CU Anschutz Campus-Wide Wayfinding Signs

Project Number: 19-182047

Addendum 4

Clarification of reference photos in Addendum 3.

1 Sign Type B: Illuminated Intent - Isometric View  
- Scale: NTS

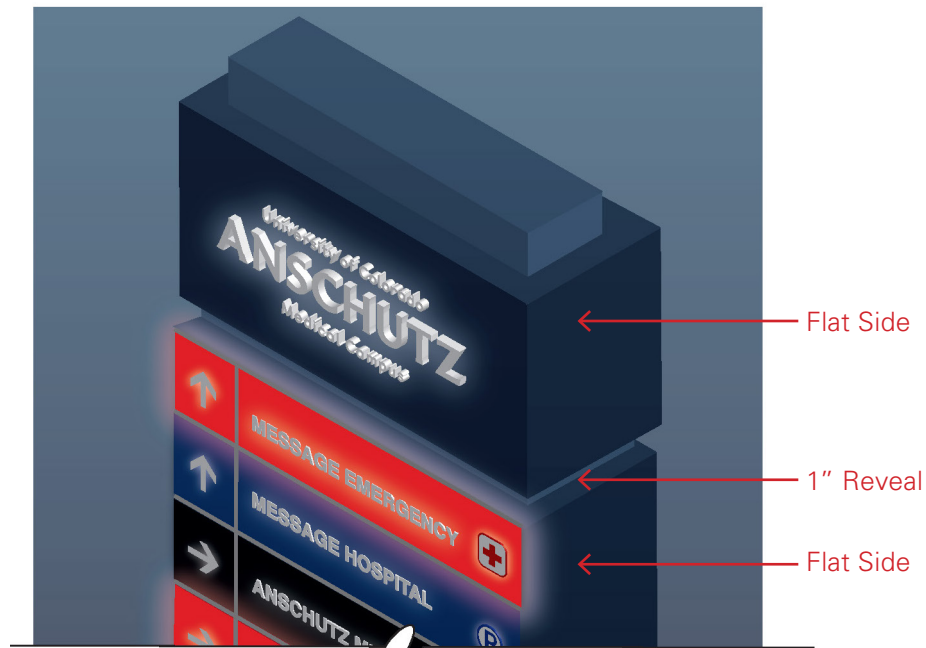
The side inset/reveal shown in the piano hinge reference photos should not be included on the new signage. The new signage should have a flat side, and 1" reveal around the top and bottom of the sign as shown in the 100% Construction Documents and Campus Sign Standards and noted below.
